## INDIANA HARBOR BELT RAILROAD COMPANY

**BULLETIN ORDER NO. S-40**  
**Effective: 0600 Sunday July 7, 2024**

**July 5, 2024**  
**General Orders in effect: 102**

**B. Revisions:****Timetable Special Instructions:****1. KANKAKEE LINE – MAP (PAGE 11) – MODIFIED 3/27/2024:**

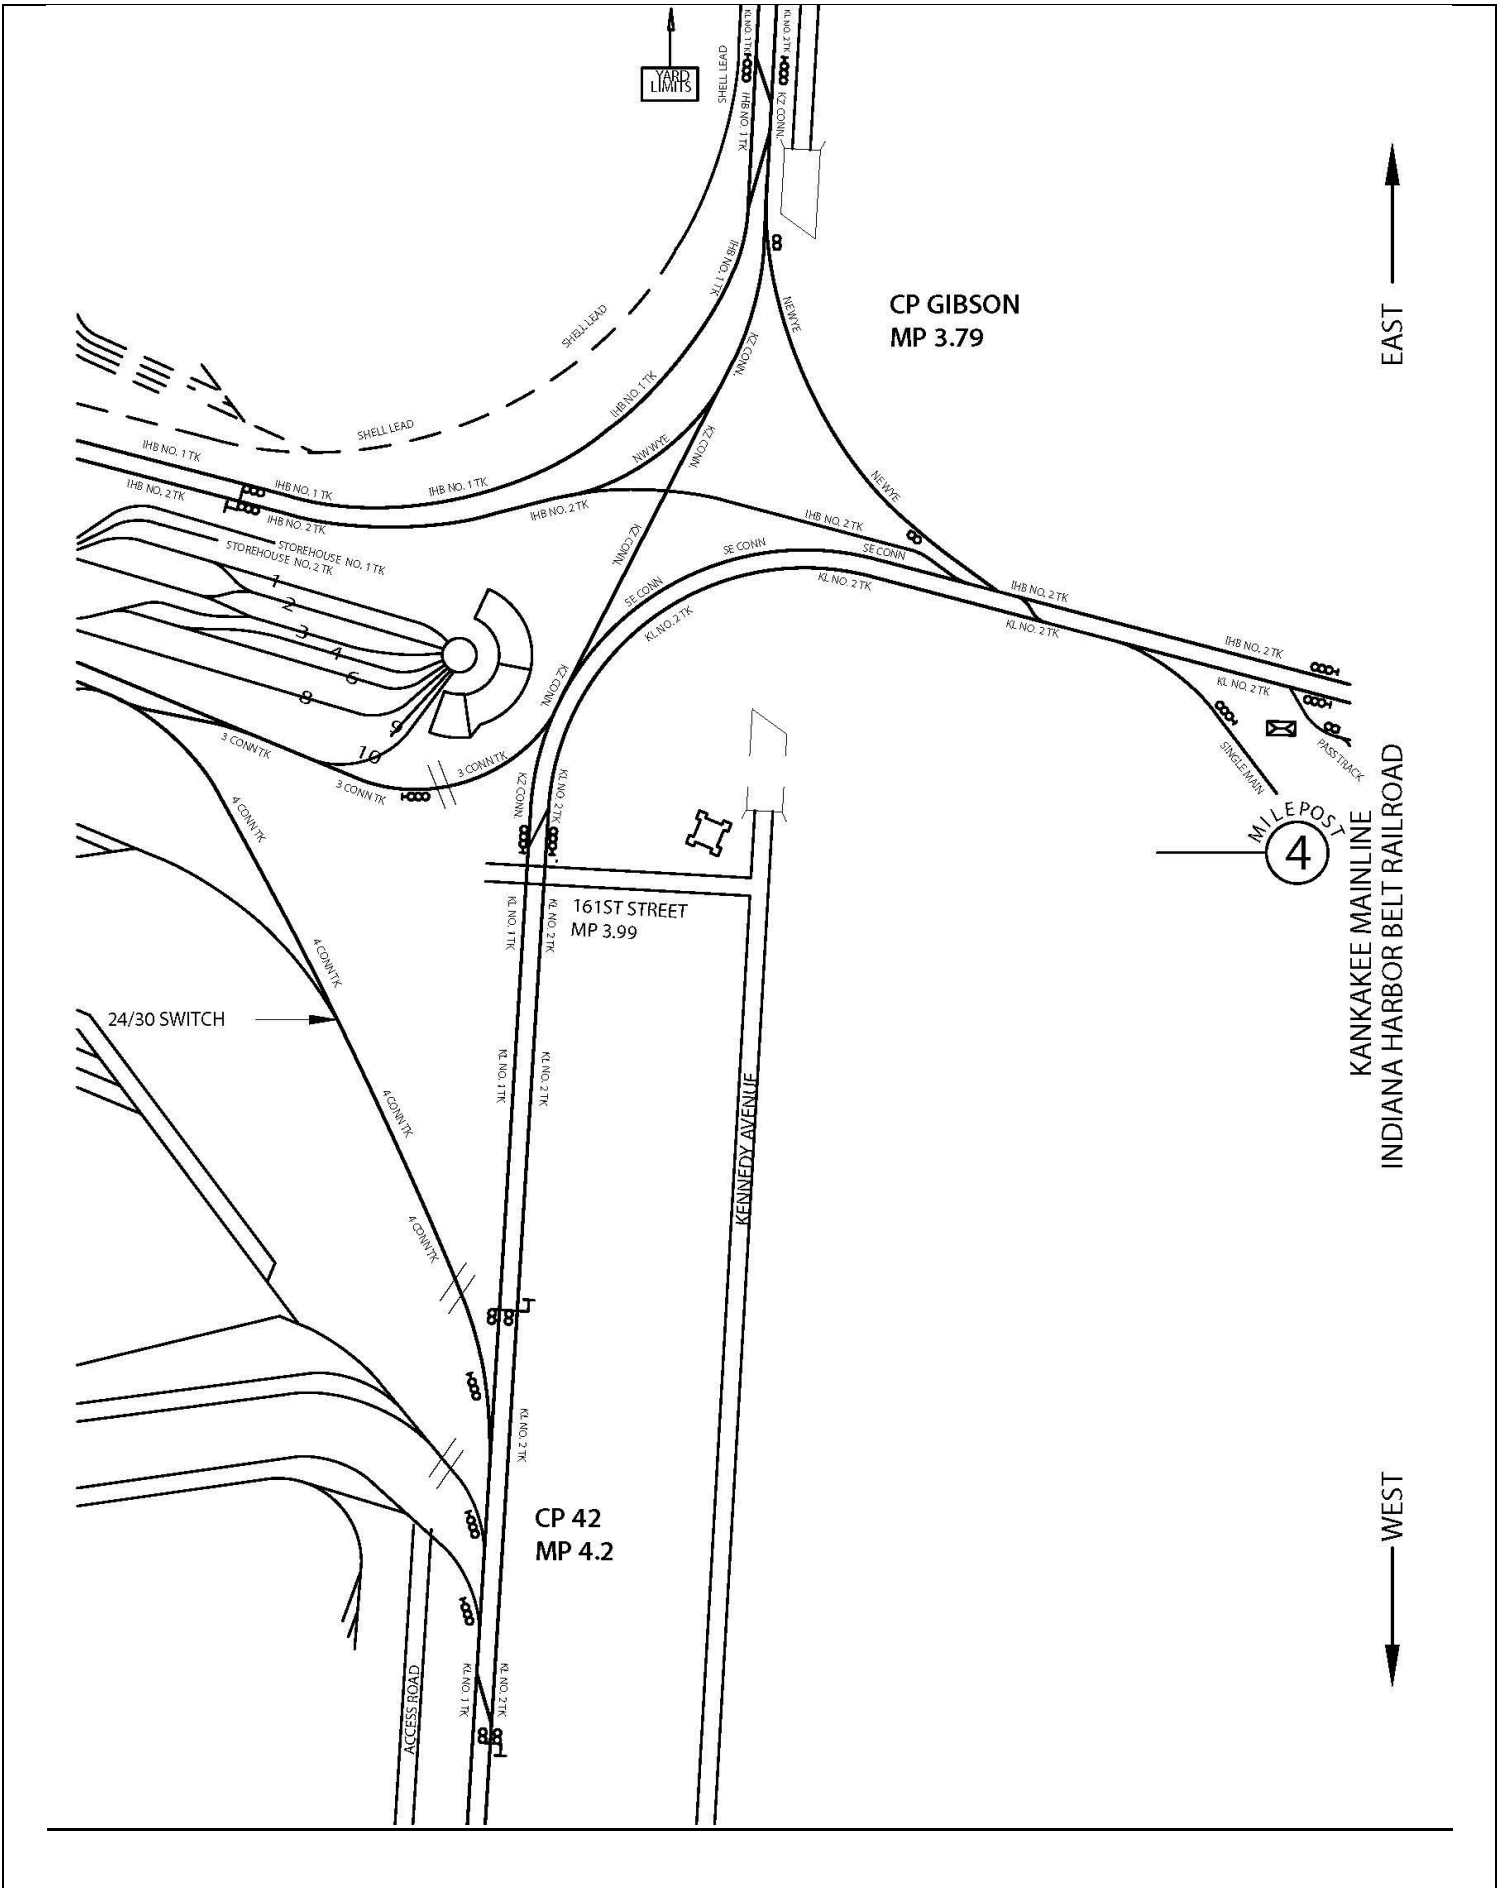
Effective 0600 3/27/2024, a replacement page will be made available at all reporting locations for page 11 of IHB Timetable No. 3. Below is a summary of the changes and an updated map. Replacement page will be available for foreign line employees for Page IHB-50 of the CORA guide:

- Turnout diverging from IHB No. 2 Track to KZ Connection has been named “NW WYE”.
- New Storehouse No. 2 Track has been placed in service at the Roundhouse. The track is located south of Storehouse No. 1 Track.

**2. KANKAKEE LINE – PHYSICAL CHARACTERISTICS TABLE – MODIFIED 3/27/2024:**

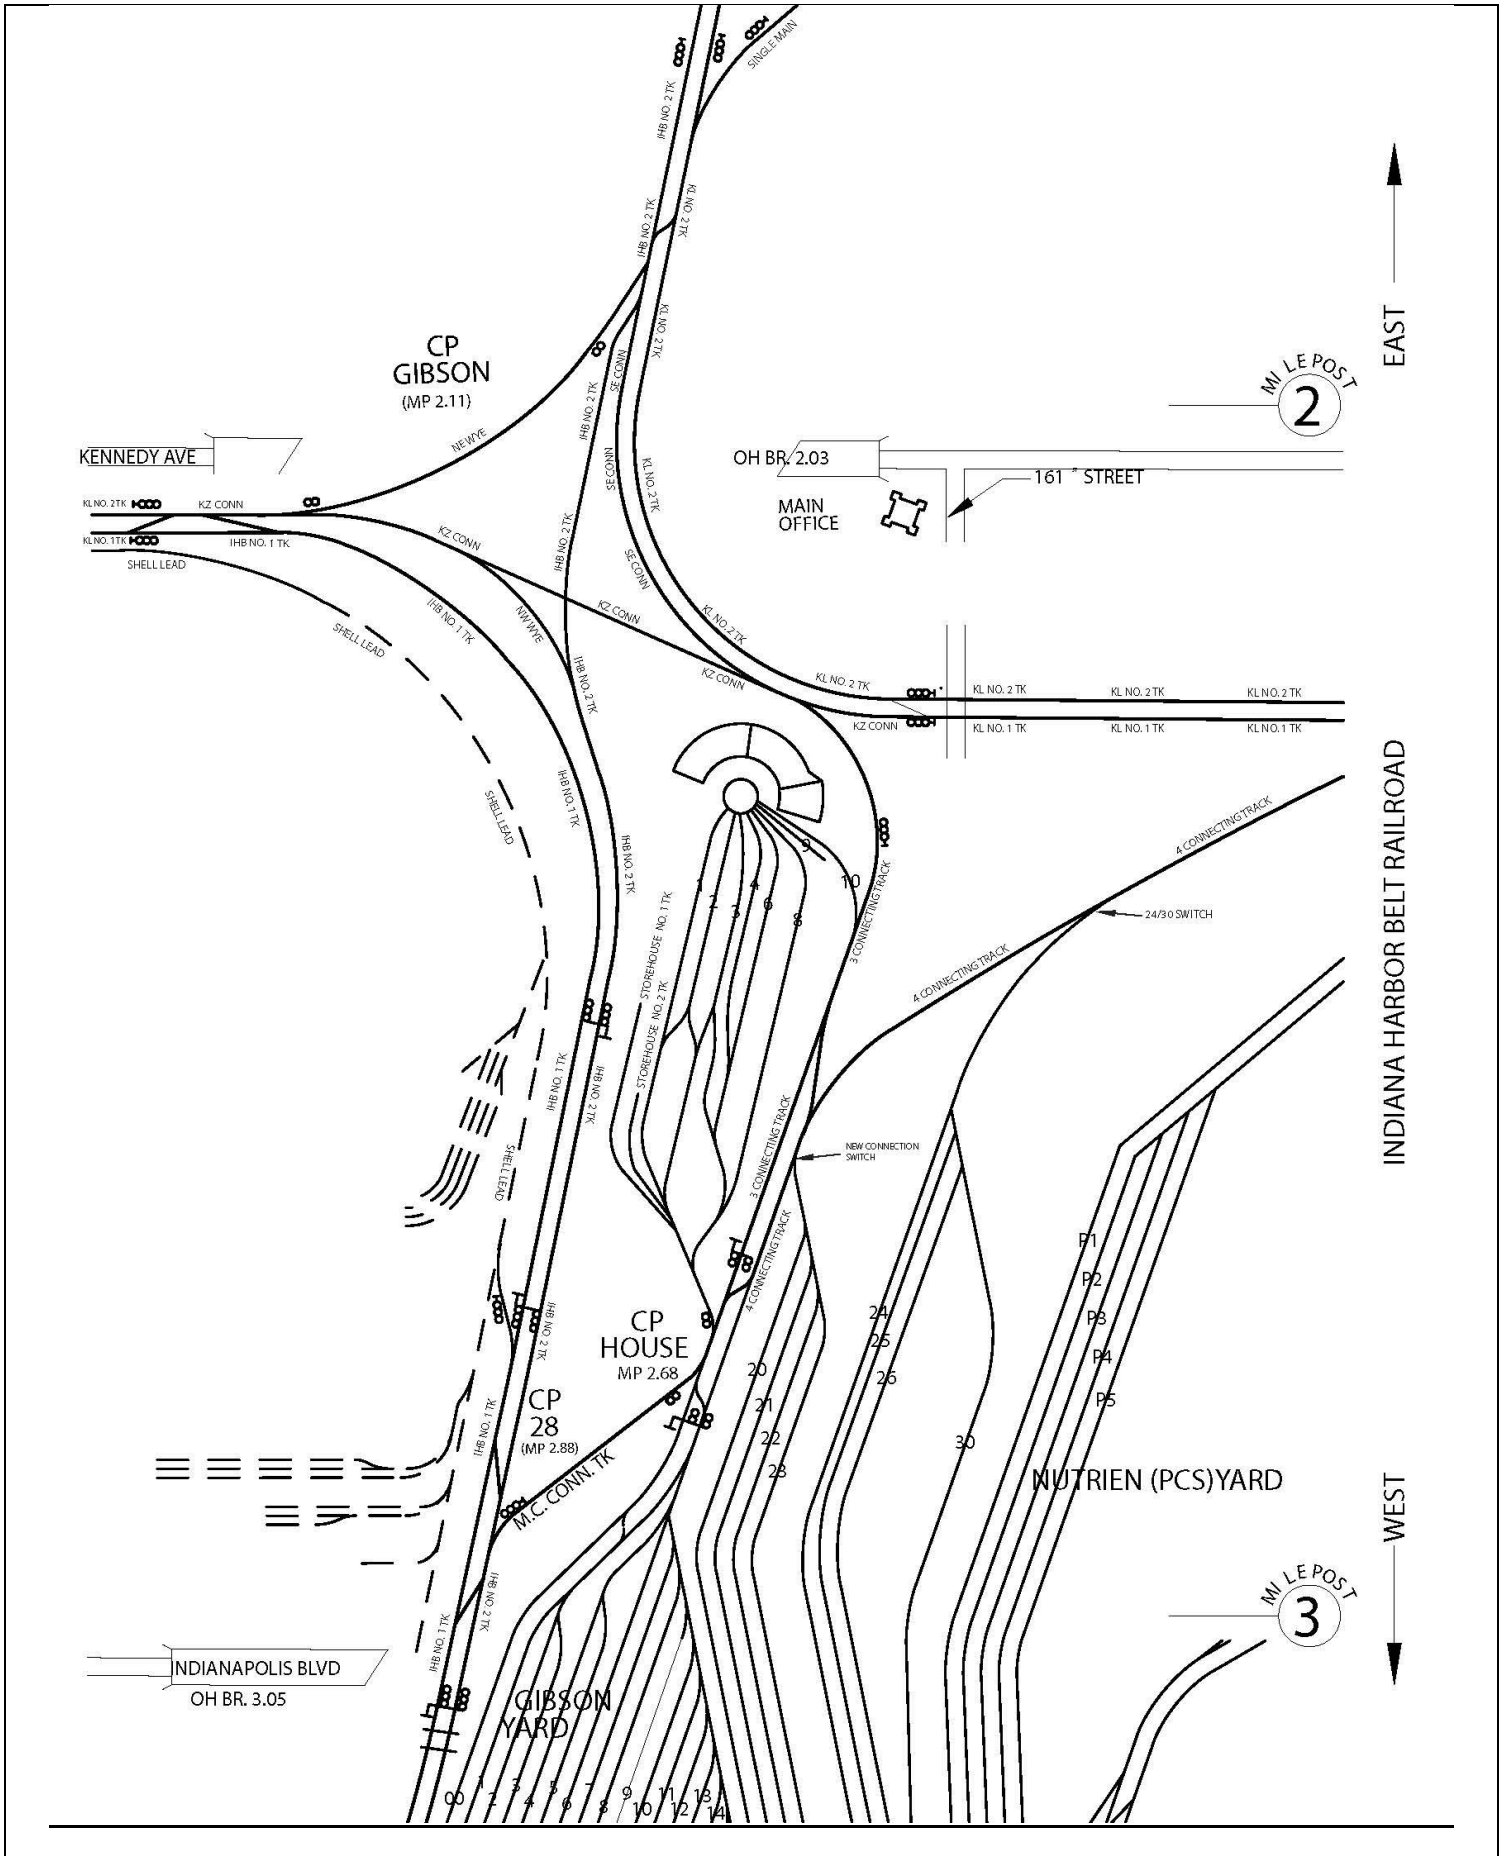
Effective 0600 3/27/2024, a replacement page will be made available at all reporting locations for page 7 of IHB Timetable No.3. Below is a summary of the changes that were made (*italicized/underlined* text represents words that were added and ~~struck through~~ text represents words that were deleted). Replacement page will be available for foreign line employees for Page IHB-46 of the CORA guide:

- AT CP Gibson:
  - IHB NO. 1 TRACK AND IHB NO. 2 TRACK - Added, “*NOTE: TRACKS ARE A PART OF THE IHB MAIN SUBDIVISION.*”
  - SE Connection – Added, “*NOTE: TRACK IS A PART OF THE IHB MAIN SUBDIVISION.*”
  - NE WYE - Added, “*NOTE: TRACK IS A PART OF THE IHB MAIN SUBDIVISION.*”
  - Note deleted and NW WYE added - Turnout diverging from IHB No. 2 Track to KZ Connection has been named “NW Wye”:
    - Deleted - “~~NOTE: SPEED AT CP GIBSON – TURNOUT SPEED WHEN DIVERGING FROM OR TO IHB NO. 2 TRACK AND KZ CONNECTION~~”
    - Added - “*AT GIBSON*” under the **LOCATION BETWEEN/AT** column, “*NW WYE – NOTE: TRACK IS A PART OF THE IHB MAIN SUBDIVISION*” under the **TRACK NAME** column, and “*CTC*” under the **RULE** column.

**21. GIBSON YARD – PHYSICAL CHARACTERISTIC CHANGES – MODIFIED 7/7/2023:**

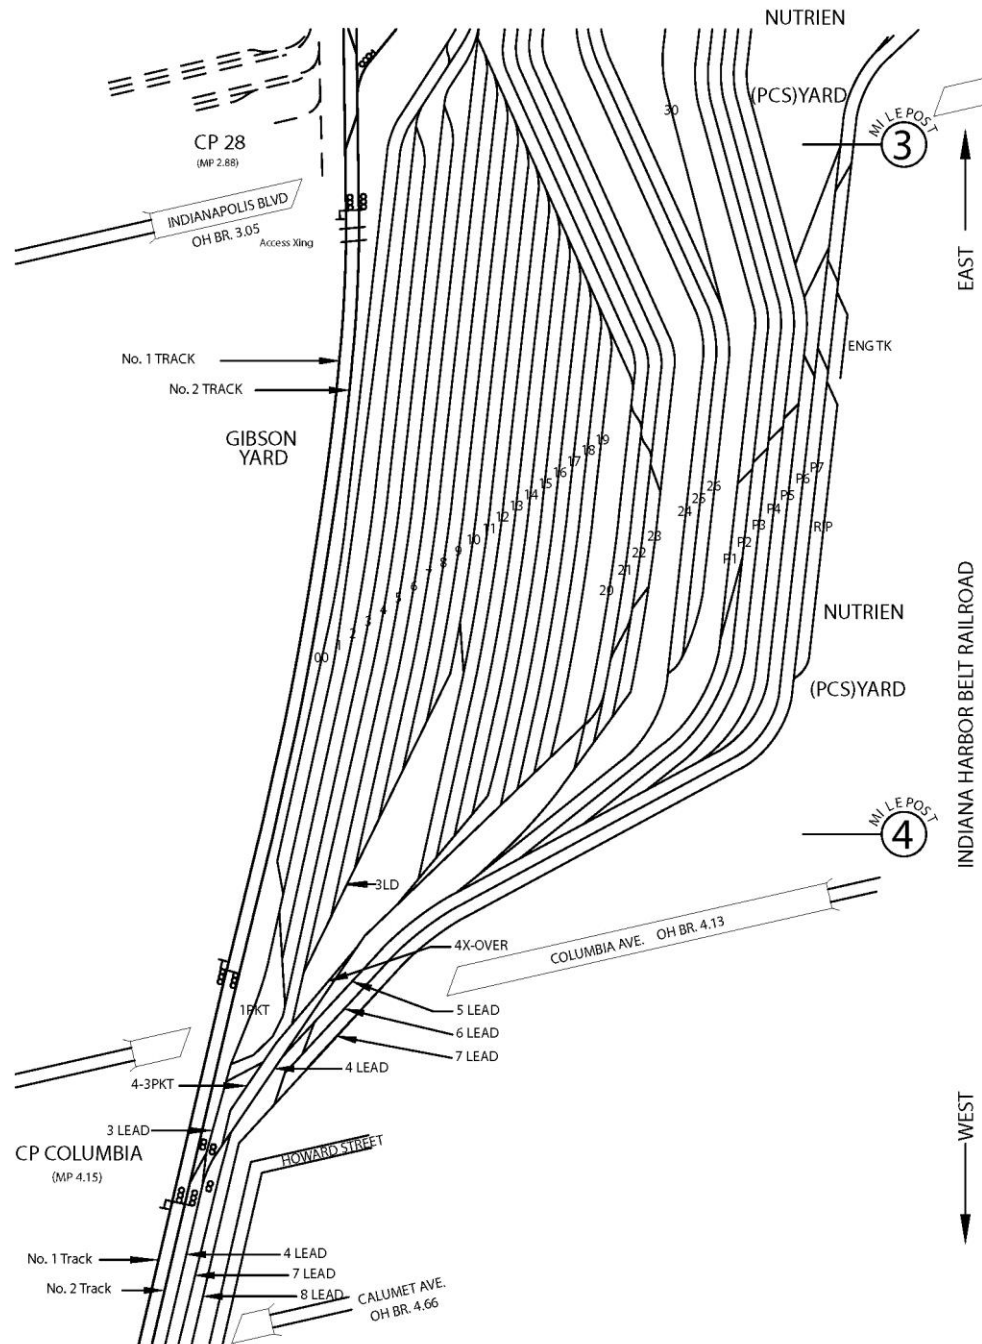
Effective 0600 6/21/2023, employees must make a note on page 20 of IHB Timetable No. 3 “See bulletin changes dated 7/7/2023” and keep a copy of new map in their possession. Foreign line crews must make the same note on Page IHB-59.

On the next page is a map of the revised configuration:

**50. GIBSON YARD MAP- MODIFIED 5/28/2022:**

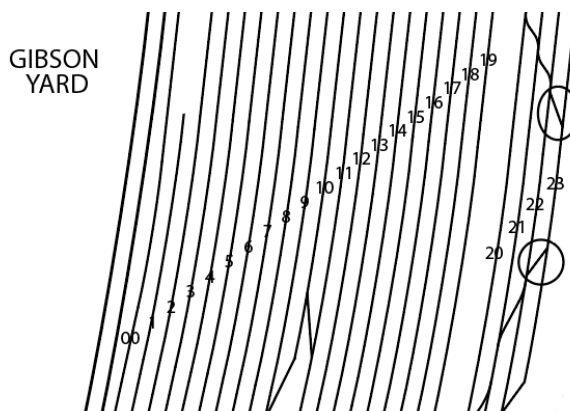
Effective 0600 5/28/2022, employees must add the two crossover switches from track 22 to track 23 (circled in the image below) in ink on page 20 of IHB Timetable No. 3. Foreign line crews must make the same modifications to Page IHB-59:

**80. KANKAKEE LINE – SPECIAL INSTRUCTIONS – MODIFIED 9/14/2021:**

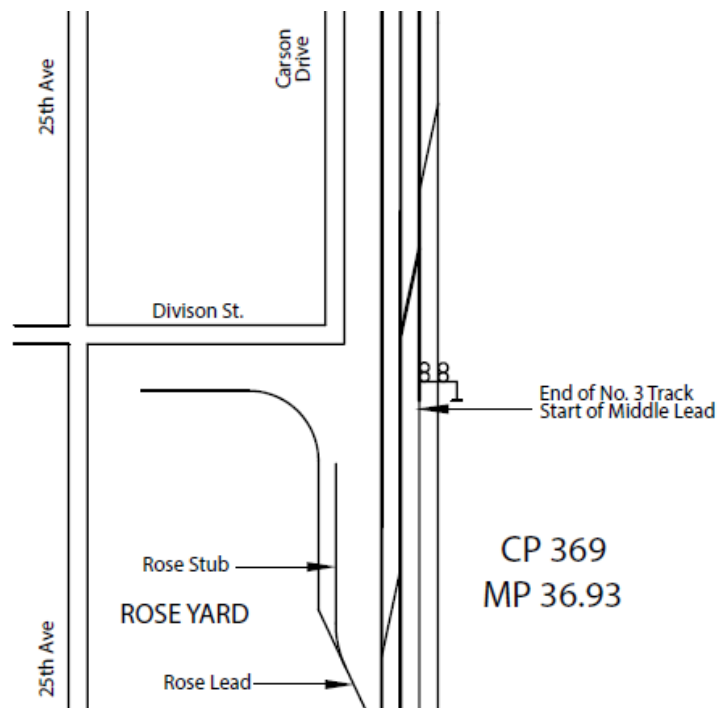
Effective 0600 9/14/2021, employees must make the following changes to the second bullet point under **SPECIAL INSTRUCTIONS** on page 7 of IHB Timetable No. 3. Strike through ~~CP GIBSON~~ and write in CP HOUSE. Foreign line crews must make the same changes to Page IHB-46 in the CORA guide. Below is how the second bullet point will read after the changes are made:

NO. 4 CONNECTING TRACK BETWEEN CP HOUSE AND CP 42: 10 MPH – RULE 6.28 IN EFFECT
